From: Mark Kirby
Sent: Wednesday, May 31, 2023 1:53 PM
To: Patrick Moss
Cc: Thomas Webster; Caroline Ford; Hannah Leary ; Rob Bolton
Subject: NW Bicester - Charlotte Avenue Info

4600-1100-T-080 Rev A – Possible One-Way Priority Along Charlotte Avenue:

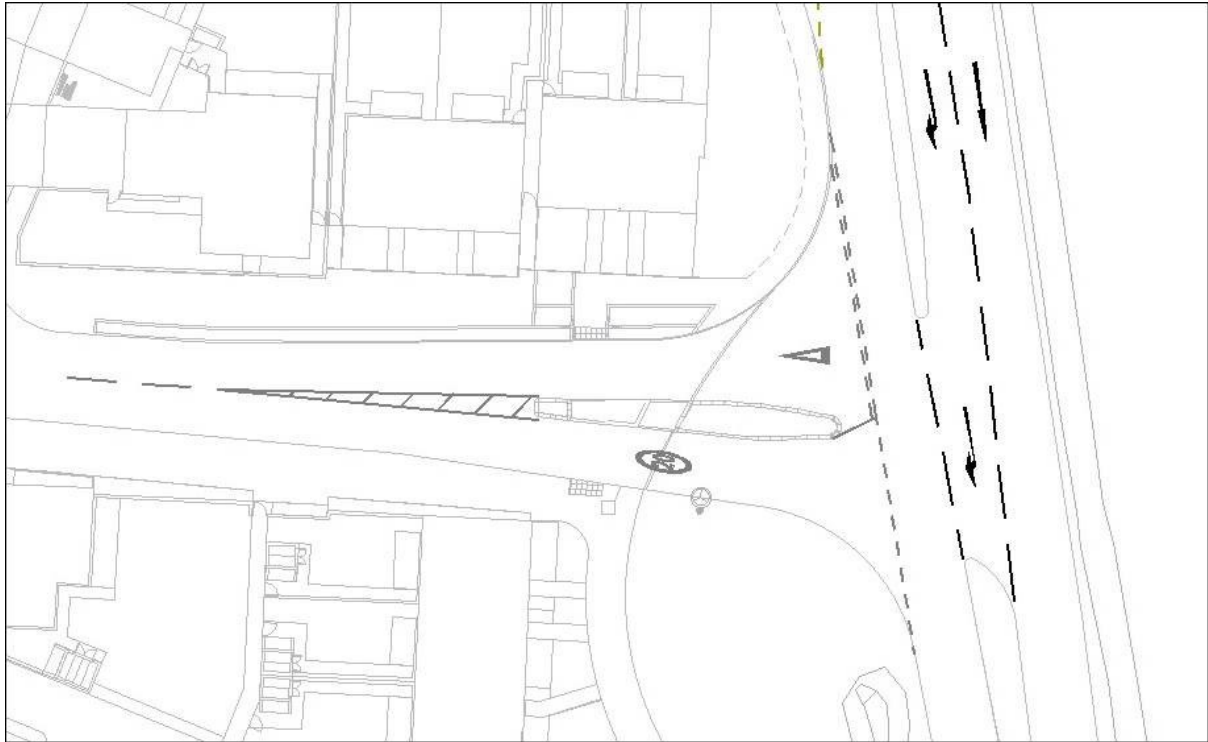
- This is the option that you generally refer to within your PoE.
- It is an alternative option to that which we presented as part of the submission, which proposed to reduce the footway width on the eastern side of the Charlotte Avenue carriageway, which is considered may have an impact on the existing trees (VTP Drawing 4600-1100-T-073 Rev A).

- As there are no physical works proposed for this priority arrangement option, with the exception of the potential kerb build out, it is not expected that there would be any impact on the trees.

- The available carriageway width at the kerb build out ensures that this is no less than 3.1m, which is the minimum width required for an emergency services vehicle.

- I considered locating the give way junction at the northern end of this stretch of Charlotte Avenue but felt that due to the fact that the give-way arrangement would be located between the junction with Rosemary Gardens and the existing bridge, it would be confusing for drivers wishing to join Charlotte Avenue from Rosemary Gardens.

- I accept that the give-way arrangement is very close to the bus stop but considering that OCC intend to ensure that a frequent bus service is provided along this stretch of Charlotte Avenue, we both agreed that the bus would not be required to stop for extended periods and therefore would have a limited impact on vehicles that are located at the give-way arrangement.

- Whilst I appreciate that you may want to review this option in more detail now that you have a copy of the drawing, if you are happy with this alternative option, might I suggest that we seek to update the SoCG between the Appellant and CDC with a view to identifying that this element can be adequately dealt with? This should provide the Inspector with confidence that this matter can be addressed by the agreed financial contribution that the Appellant has agreed to the Local Highway Improvements, which will include the works that OCC deem necessary to this part of Charlotte Avenue.
